Exhibit M

THE INSTALLATION AND PERFORMANCE OF INTERNAL REPAIR SEALS AT COMMONWEALTH AVENUE, NEWTON, MASSACHUSETTS, USA

Date of Report: 30 August 2000

Fig 3 – Joint detail of Brico InnerSeal steel bands

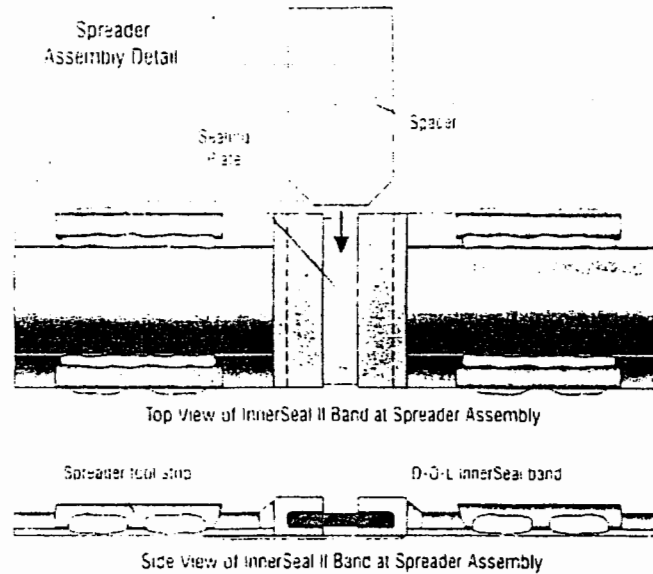
- 2.10 After jacking apart, a spacer is pushed or hammered into the slots in the end blocks (see Fig 3). Welded onto the outer face of one of the blocks is a thin metal plate, intended to spread the load across the joint area where there is no direct compression from the steel band itself. Especially if the joint expansion is high, and the spacer gap is therefore large, the thin plate may have to bridge a distance of approximately 2", with no support from the band or the spacer over this length.

Fig 4 – Ends of Brico steel bands, showing the thin bridging plates

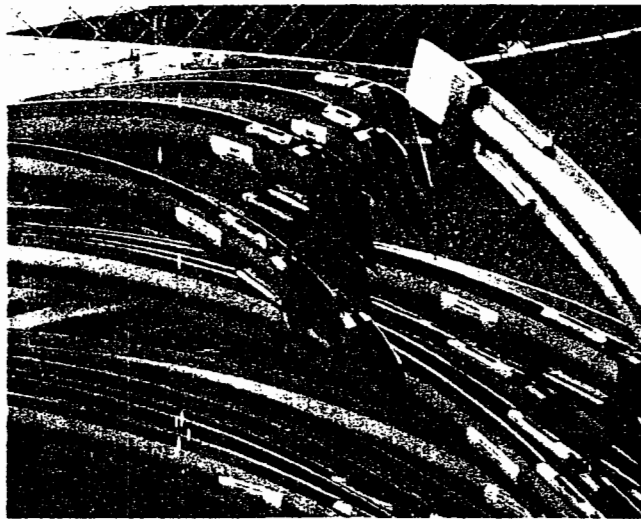
- 2.11 Some of the end blocks on the Brico steel bands appeared to have been welded on at a slight angle. In such cases, the support offered to the bridging plate may have been reduced (see Fig 5 below).

Fig 7 – Steel bands and wedge used in Miller seal

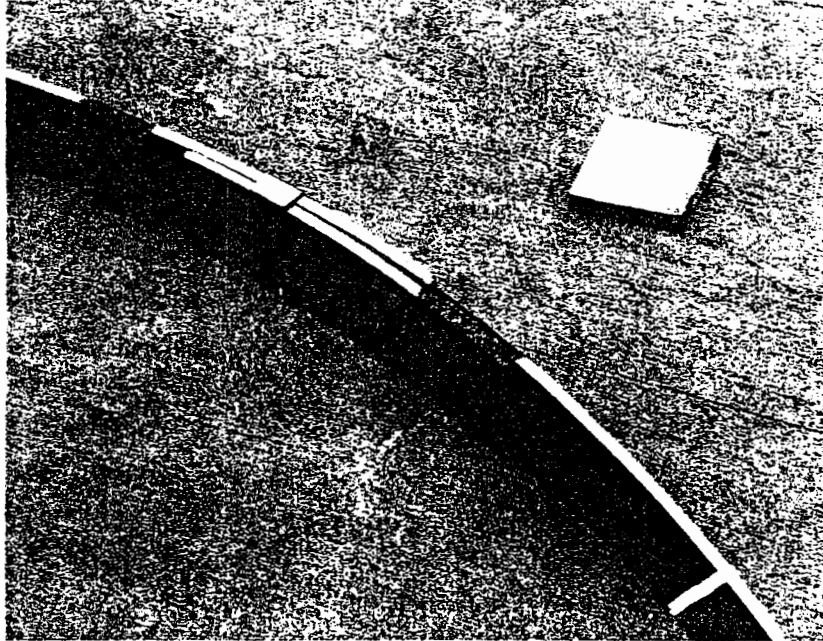
- 2.16 The Miller steel bands were in two main parts, with joints diametrically opposite. After positioning the bands within the slot in the rubber sleeve, a wedge of suitable length of was inserted at one side. A thin steel shim was then positioned under the joint at the opposite side, and the jacking load was applied here. After jacking was finished, a tight-fit wedge was hammered in to maintain the contact pressure. This wedge fitted between the main band and the thin shim which was in contact with the rubber seal.
- 2.17 The wedges for the Miller seals were cut from the same curved stock as the main band, with the objective of transmitting a fairly uniform radial force from the band, through the wedge and the thin shim, to the rubber seal.
